ATTACHMENT "B"

TECHNICAL SPECIFICATION REVISIONS

D. C. COOK UNIT 2

AEP:NRC:0575

Figure 3.2-1 ALLOWABLE DEVIATION FROM TARGET FLUX DIFFERENCE

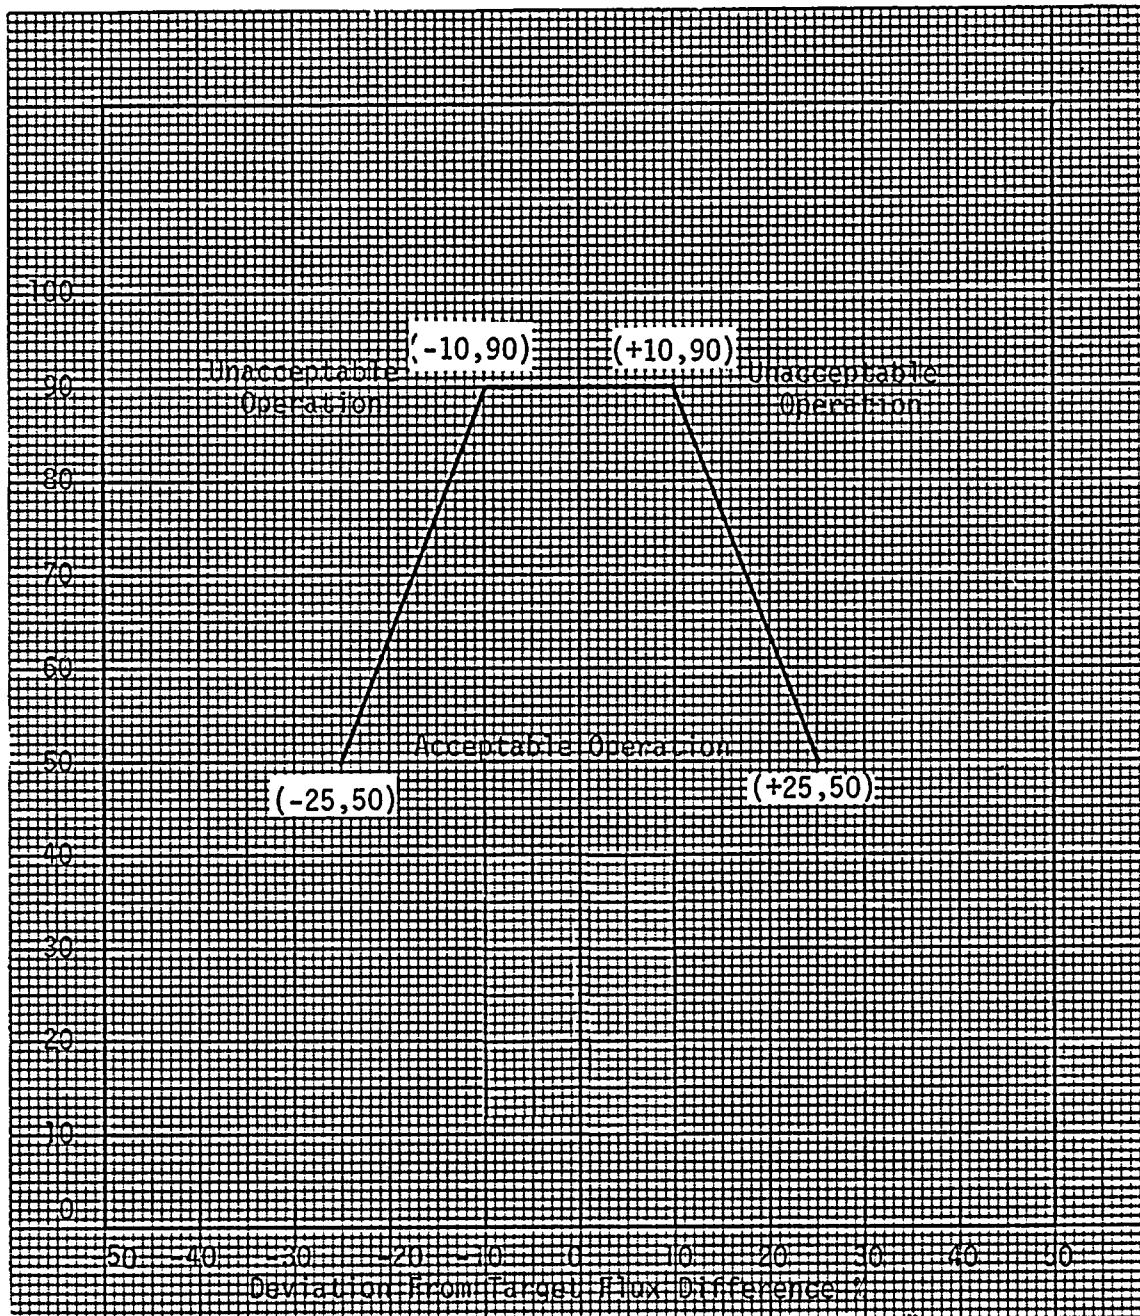
- 2) The indicated AFD is within the limits shown on Figure 3.2-1. Otherwise, reduce THERMAL POWER to less than 50% of RATED THERMAL POWER within 30 minutes and reduce the Power Range Neutron Flux-High Trip Setpoints to  $< 55\%$  of RATED THERMAL POWER within the next 4 hours.

- b) Surveillance testing of the Power Range Neutron Flux Channels may be performed pursuant to Specification 4.3.1.1.1 provided the indicated AFD is maintained within the limits of Figure 3.2-1. A total of 16 hours operation may be accumulated with the AFD outside of the target band during this testing without penalty deviation.

- c) Surveillance testing of the APDMS may be performed pursuant to Specification 4.3.3.7.1 provided the indicated AFD is maintained within the limits of Figure 3.2-1. A total of 6 hours of operation may be accumulated with the AFD outside of the target band during this testing without penalty deviation.
- b. THERMAL POWER shall not be increased above 90% or  $0.9 \times \text{APL}$  (whichever is less) of RATED THERMAL POWER unless the indicated AFD is within the  $\pm 5\%$  target band and ACTION 2.a) 1), above has been satisfied.
- c. THERMAL POWER shall not be increased above 50% of RATED THERMAL POWER unless the indicated AFD has not been outside of the  $\pm 5\%$  target band for more than 1 hour penalty deviation cumulative during the previous 24 hours.

Figure 3.2-3  $V(Z)$  As A Function Of Core Height

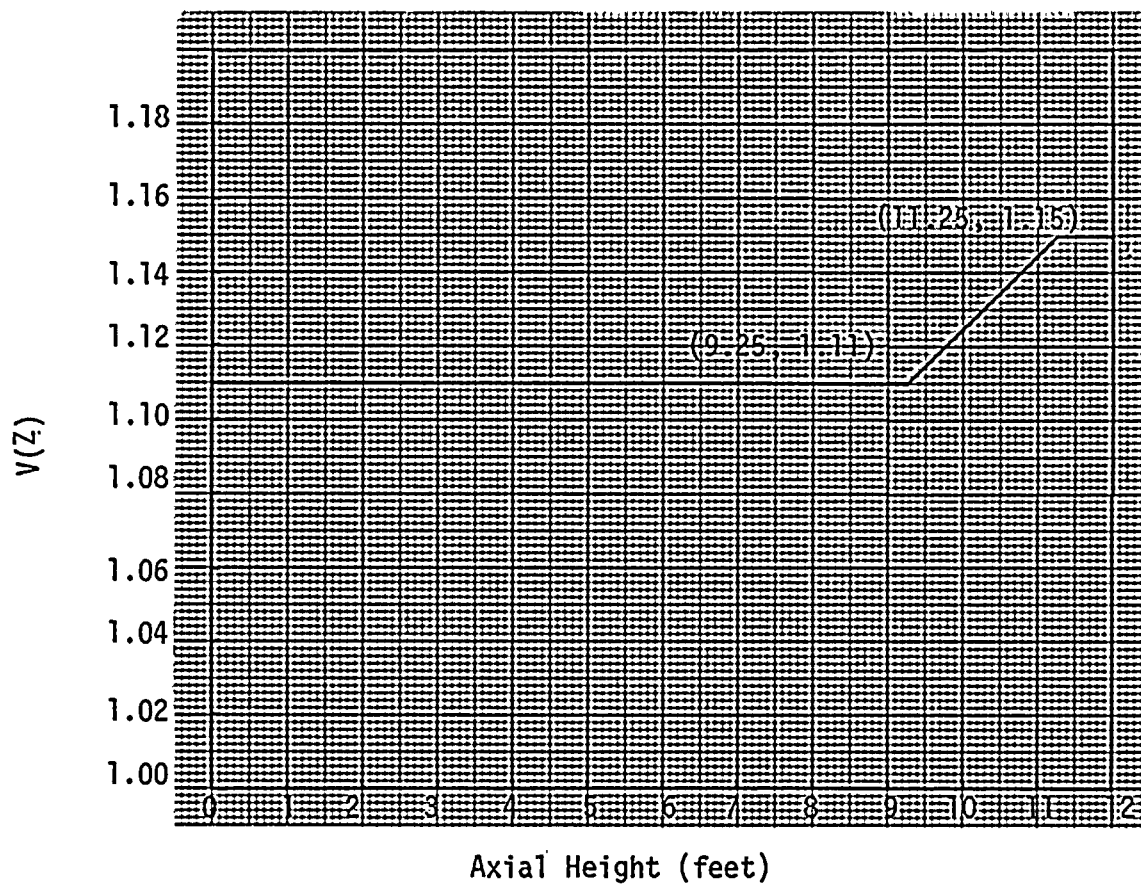
$V(Z)$  is the function defined in Figure 3.2-3,  $K(Z)$  is defined in Figure 3.2-2,  $P$  is the fraction of RATED THERMAL POWER.

$$\left[ \left[ \text{max. over } Z \text{ of } \frac{F_Q^M(Z) \times V(Z)}{\frac{1.99}{P} \times [K(Z)]} \right] - 1 \right] \times 100 \quad P \geq .5$$

$$\text{APL} = \min \text{ over } Z \text{ of } \frac{1.99 K(Z)}{F_Q(Z) \times V(Z)} \times 100\% \quad P > .5$$
